Process Sheet

Customer	: CU-DAR001 Dart Helicopters Services	Drawing Name	: STUB COVER
Job Number	: 41956		
Estimate Number	: 12415		
P.O. Number	:	Part Number	: D34941
This Issue	: 10/09/2008 S.O. No. :	Drawing Number	: D3494 REVB
Prsht Rev.	: NC	Project Number	: N/A
First Issue	: / / Type : SMALL /MED FAB	Drawing Revision	: B
Previous Run	: 38900	Material	:
Written By	:	Due Date	: 30/09/2008 Qty: 10 Um: Each
Checked & Approved By	: <u>JLO 08.9.11</u>		
Comment	: Est Rev:A New Issue 06-05-18 JLM est rev B ecn 888 06.12.13 EC

DESIGN <i>PH</i>	DRAWN BY <i>PH</i>	DART AEROSPACE LTD HAWKESBURY, ONTARIO, CANADA	
CHECKED <i>PH</i>	APPROVED <i>PH</i>	DRAWING NO. D3494	REV. B SHEET 1 OF 2
DATE 06.11.28		TITLE STUB COVER	SCALE 1:2
REV A	DATE 06.01.16	DESCRIPTION NEW ISSUE	
B	06.11.28	REVISED FLAT PATTERN, BENDING DIMENSIONS, Ø0.208 X 0.268 SLOTS WERE Ø0.208 HOLES

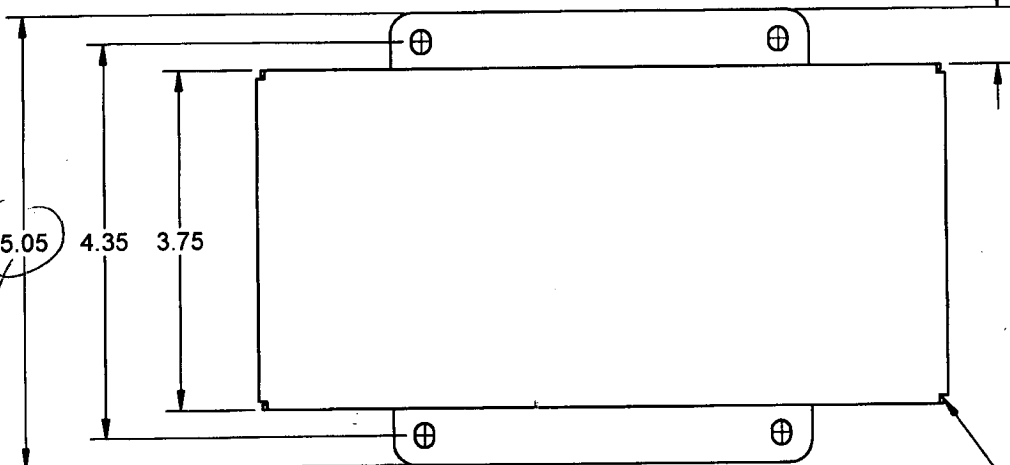
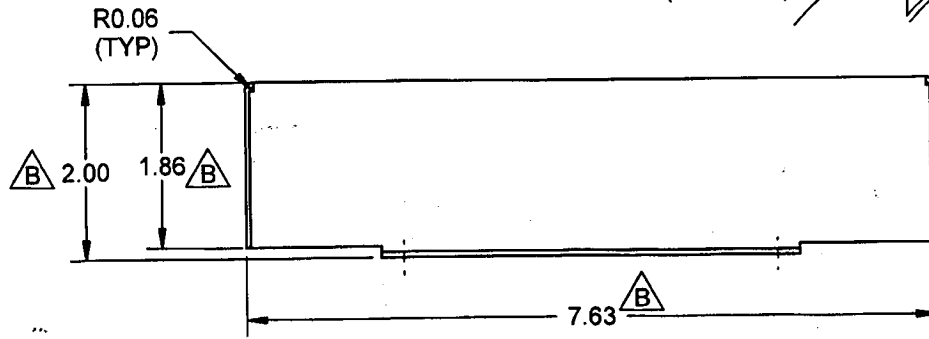
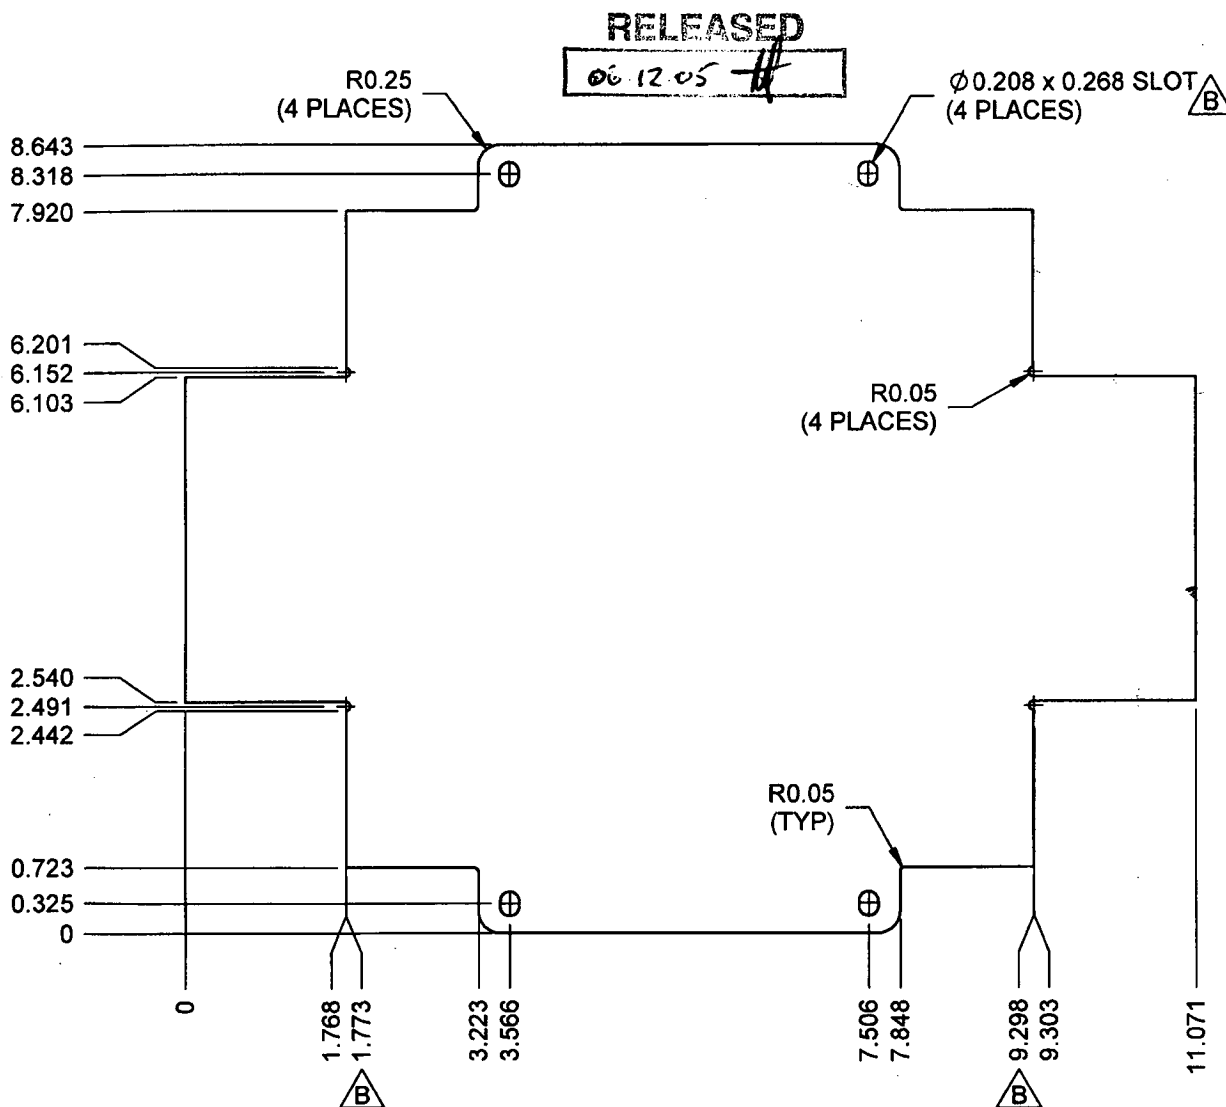
UNDER REVIEW

UPDATE BEND
DIMENSIONS

0.65 (TYP, REF)

0.72
